ADDENDUM NO. 2

Date of Addendum: November 6, 2020

Owner: City of Thompson Falls

CITY OF THOMPSON FALLS, MONTANA WASTEWATER SYSTEM IMPROVEMENTS CONSTRUCTION PLANS

PLAN VIEW OF LIFT STATION #1

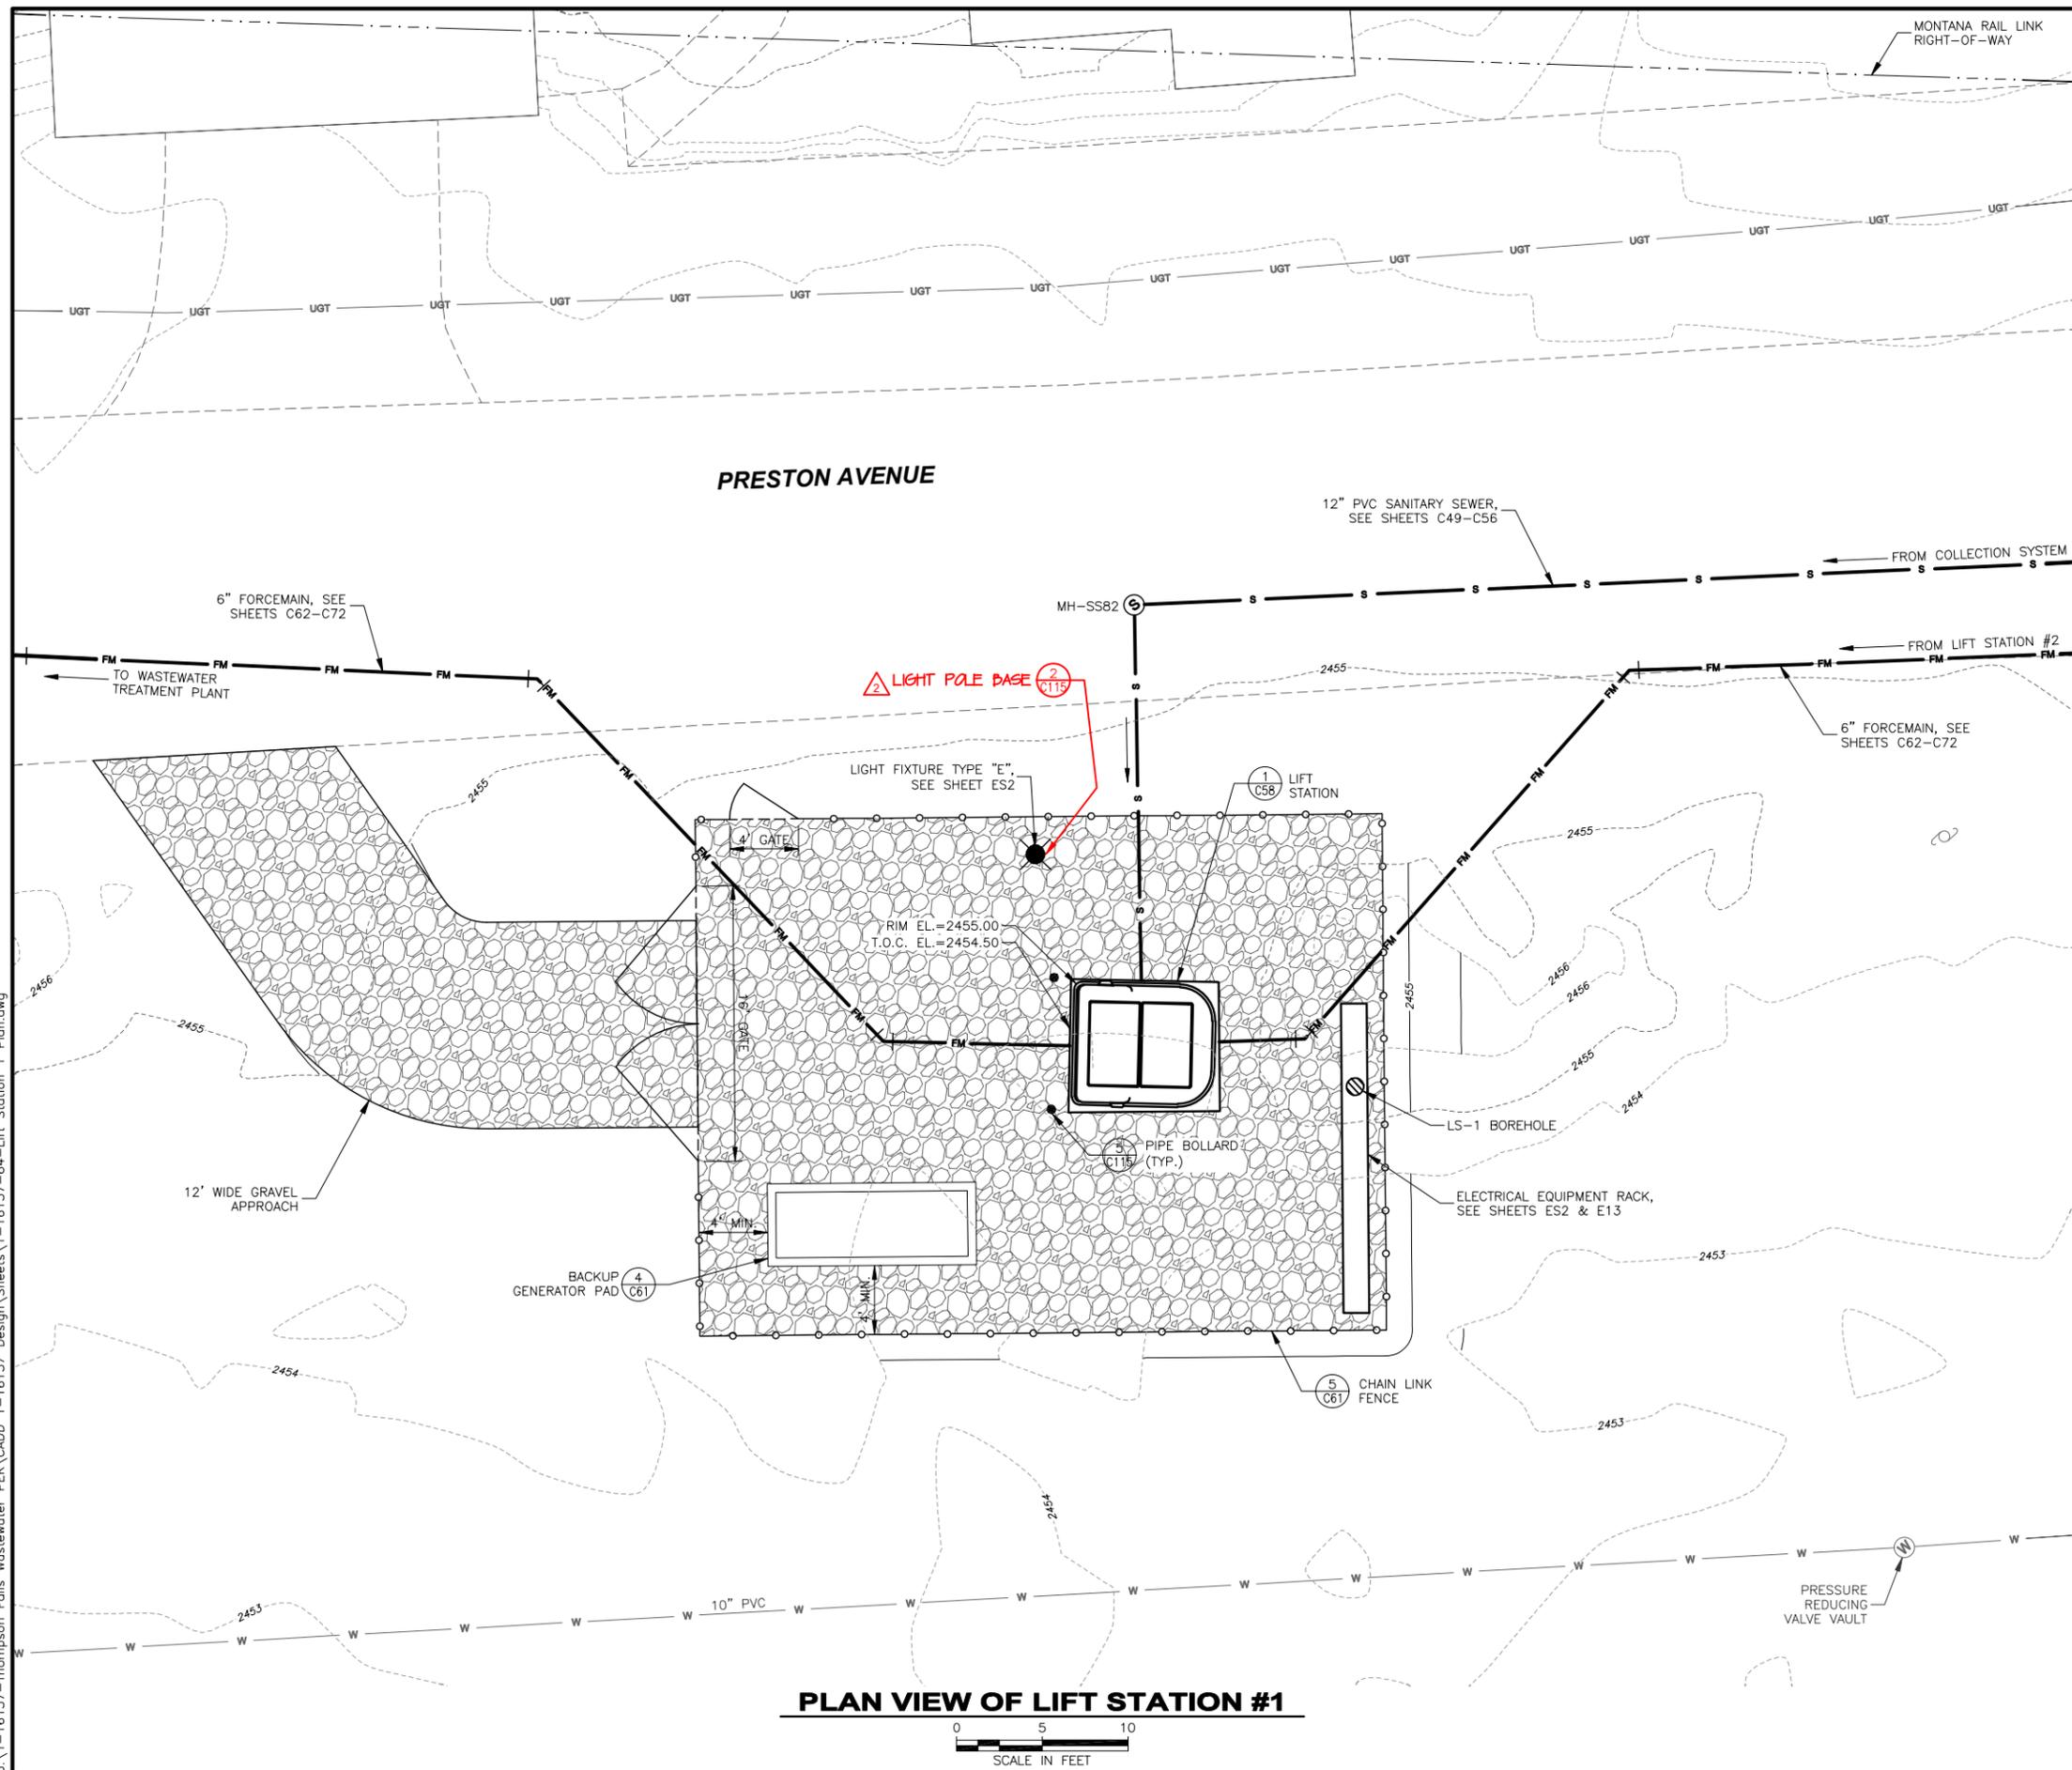
- a. Remove and replace Sheet G1 - Cover
 - i. Revisions as noted in revision description table
 - b. Remove and replace Sheet C57 - Lift Station #1 Plan

- i. Light Pole Base detail reference has been added.
 - c. Remove and replace Sheet C59 - Lift Station #2 Plan
 - i. Light Pole Base detail reference has been added.

PLAN VIEW OF PROPOSED LAGOON SITE & PROCESS PIPING LAYOUT

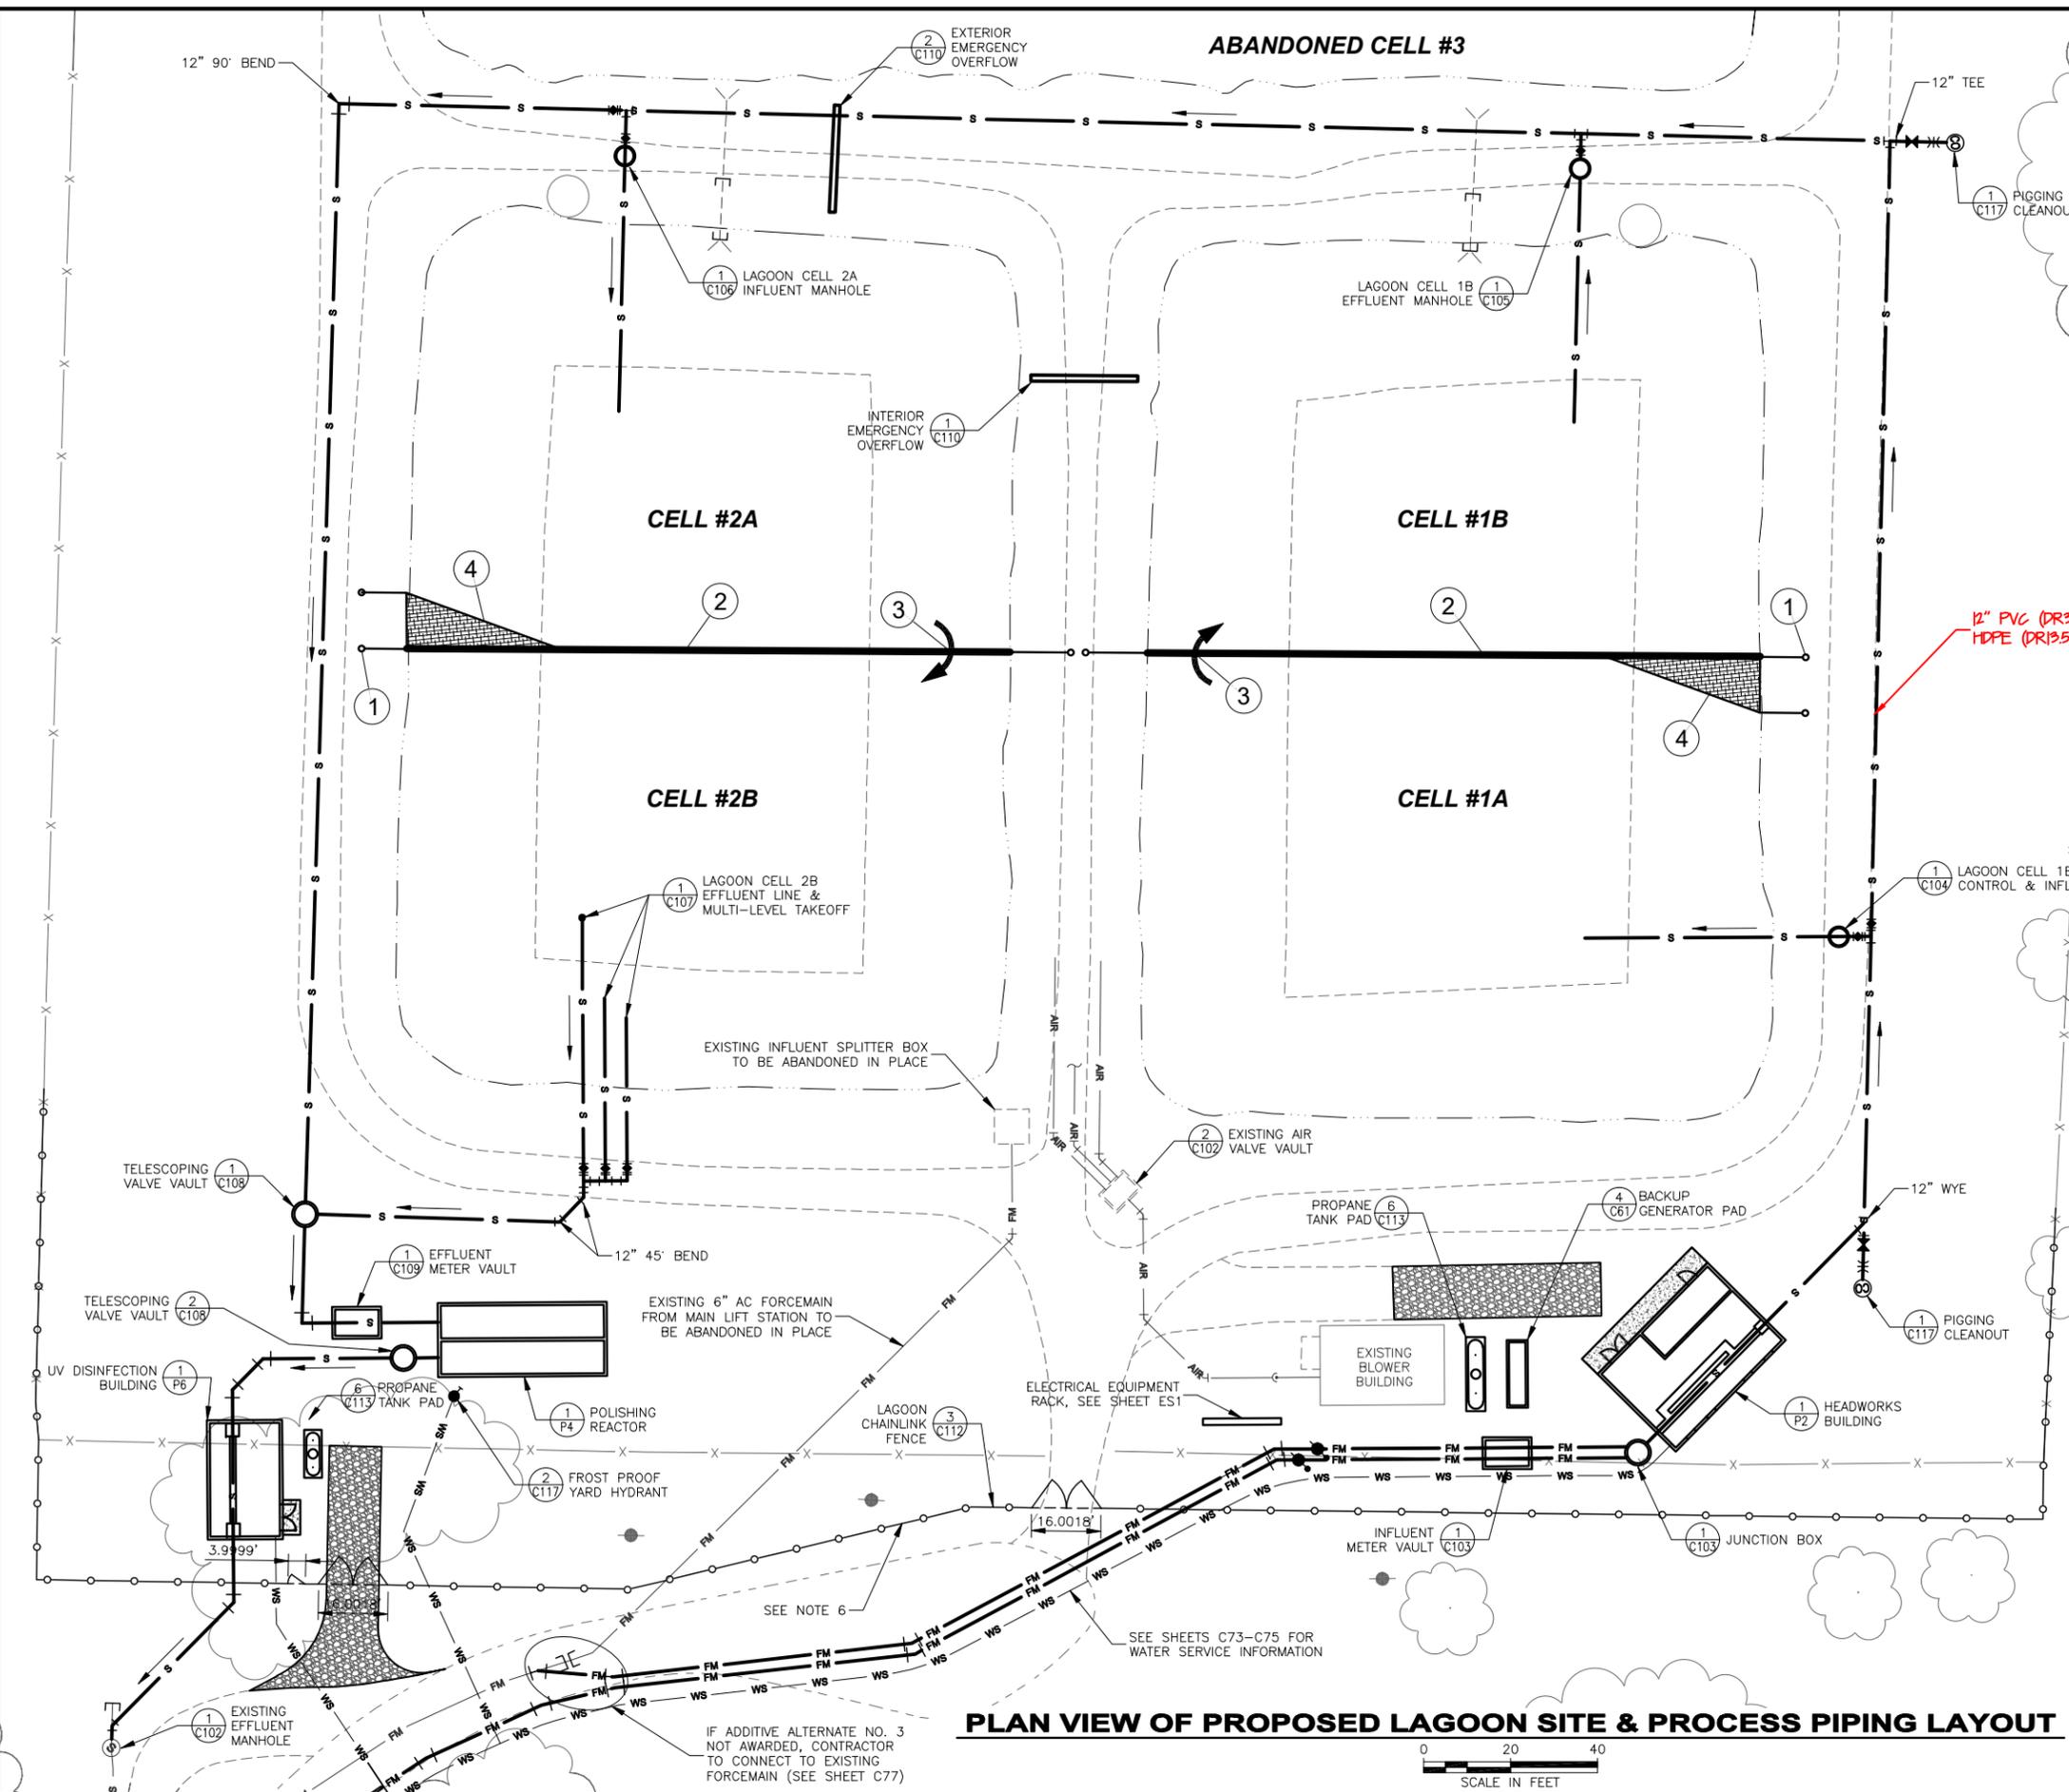
- i. Light Pole Base detail reference has been added.
 - f. Remove and replace Sheet C95 - Proposed Lagoon Site & Process Piping Layout
 - i. Reference added for clarification on lagoon pipe to be 12" PVC (DR32.5 or DR25), HDPE (DR13.5), or DIP.

PLAN VIEW OF PROPOSED AERATION PIPING LAYOUT

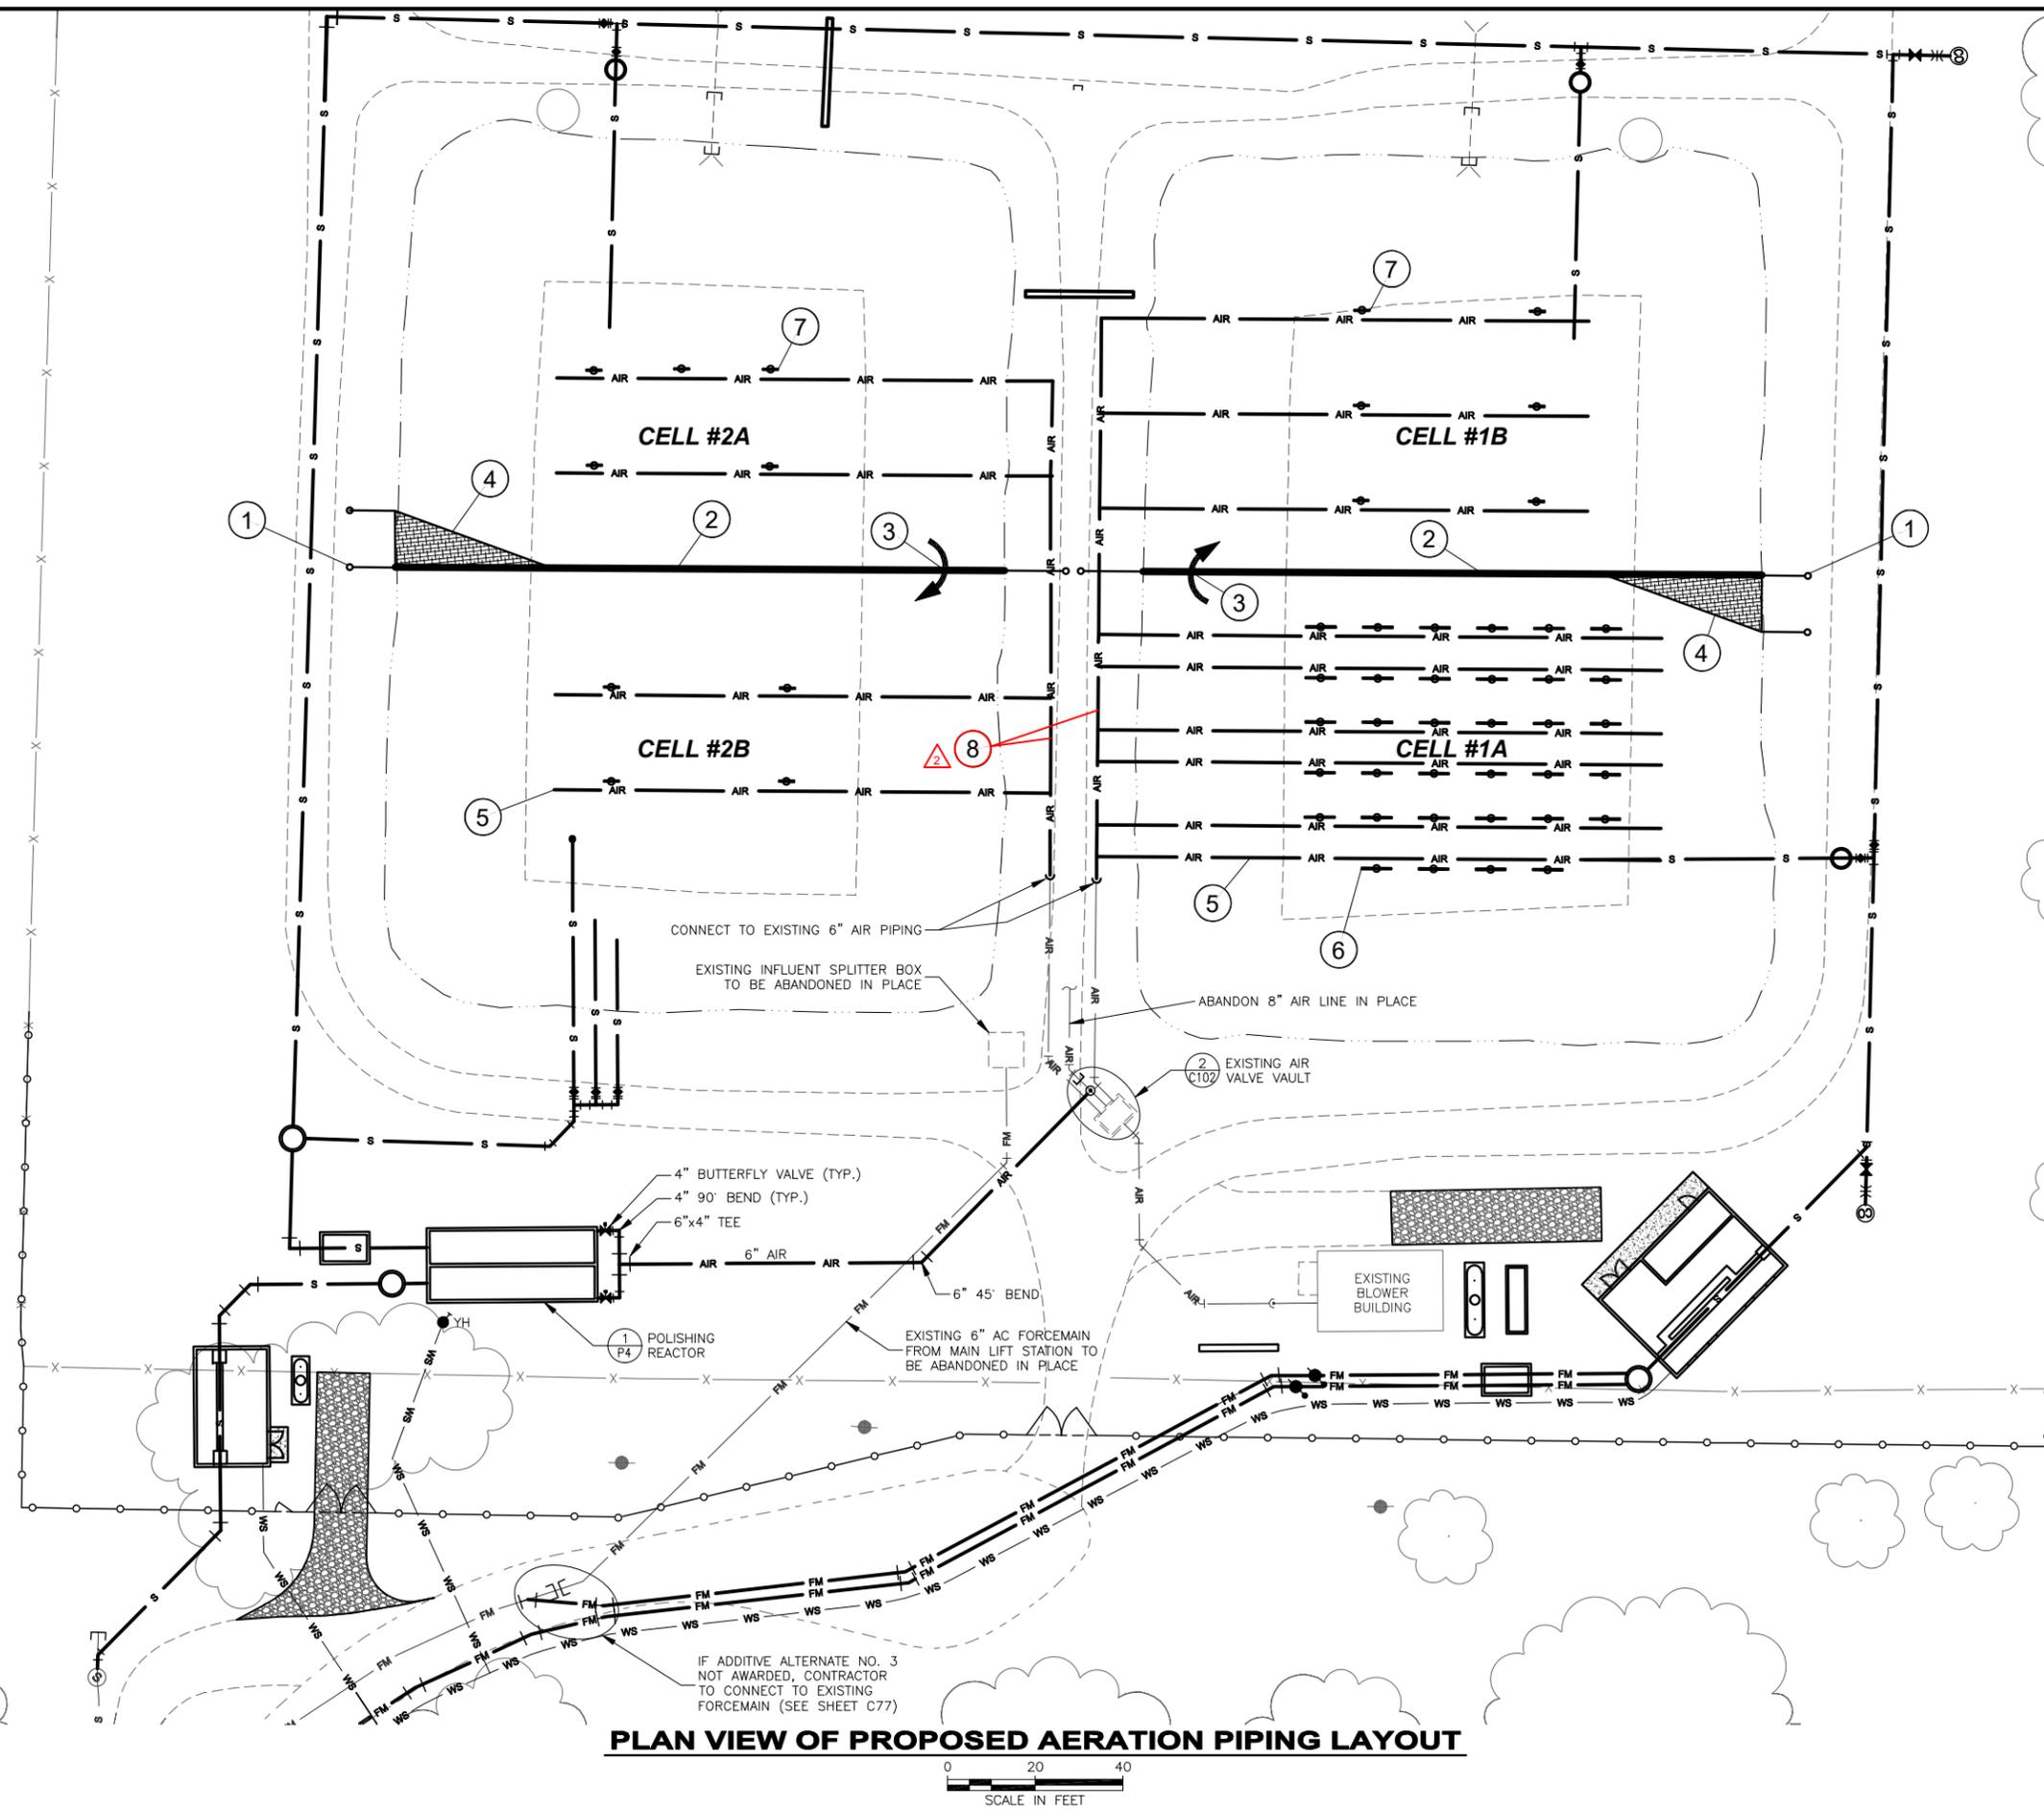
- g. Remove and replace Sheet C96 - Proposed Aeration Piping Layout
 - i. Lagoon Treatment Material & Equipment List note 8 added to clarify 6" HDPE or DI Air piping as shown on the plan sheet.
